**CITY OF KELOWNA****MEMORANDUM**

Date: May 4, 2017
File No.: S17-0034
To: Community Planning (LK)
From: Development Engineering Manager (SM)
Subject: Subdivision Application – PLR Requirements

LOCATION: 4264 Lakeshore Rd	ZONE RU6
APPLICANT: 1040711 BC LTD	
LEGAL: Lot 11 Plan 4610

Subject: 4264 Lakeshore Road RU1 to RU6

**SITE PLAN OF LOT 11 DISTRICT LOT
167 OSOYOOS DIVISION YALE
DISTRICT PLAN 4610**

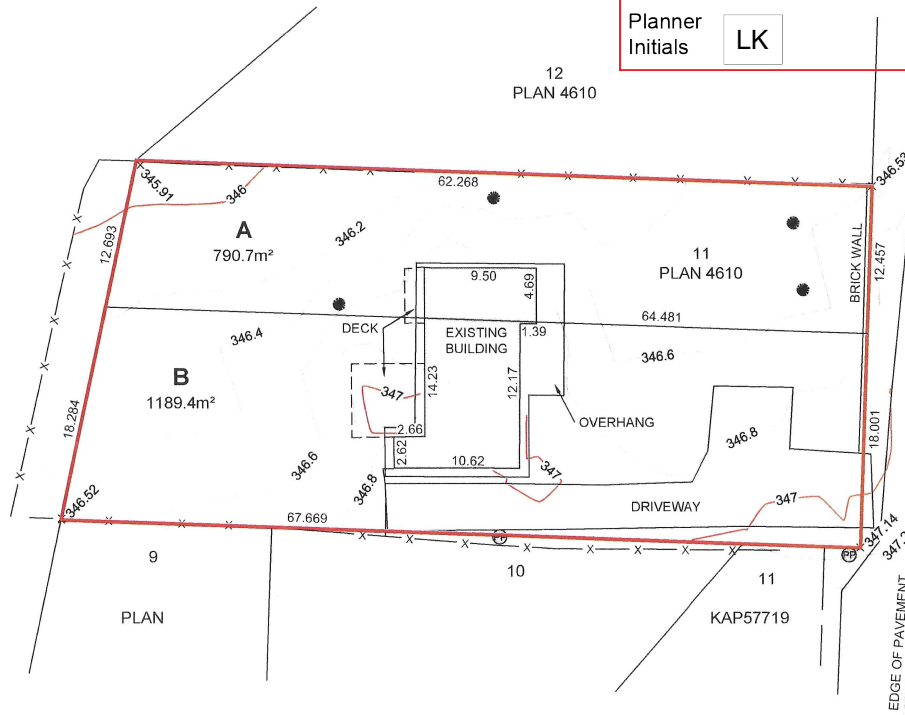
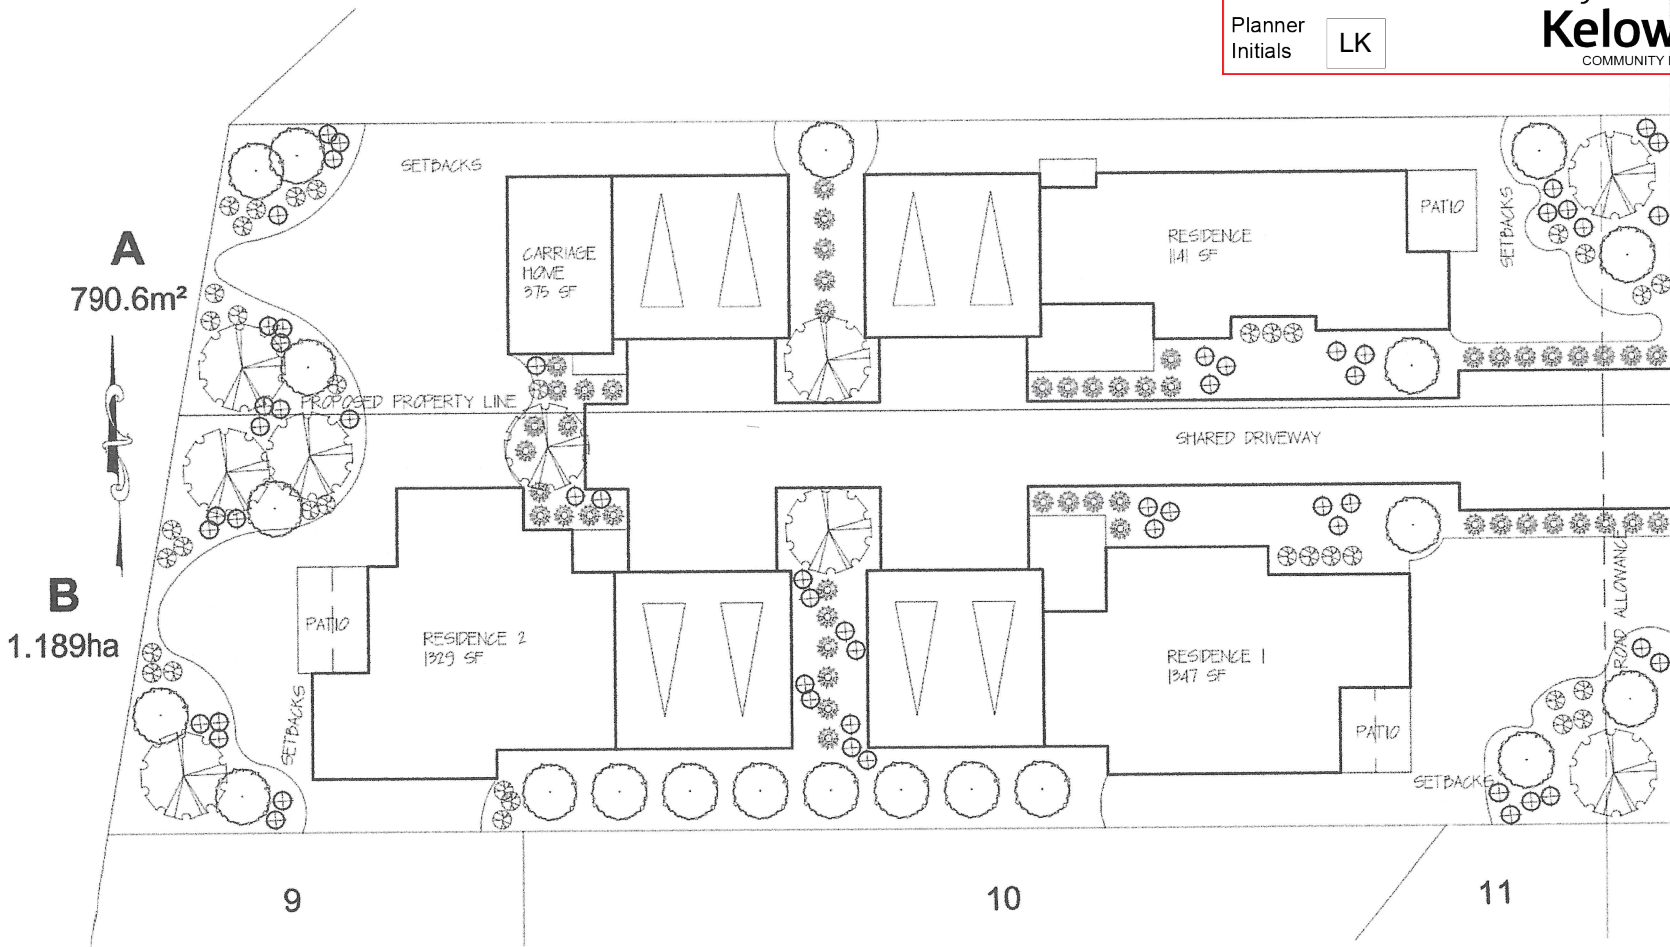
- a) Dedicate 3.0m width and a 3.0m road reserve along the full frontage of Lakeshore Rd. The existing fence and gate post must be removed.
- b) Grant statutory rights-of-way if required for utility services.

- i) The driveway access to the properties from Lakeshore Rd must be a shared access.
- ii) Furthermore, it is advised that in the future, access and egress to and from the site may be restricted to right-in and right-out due to a future median.
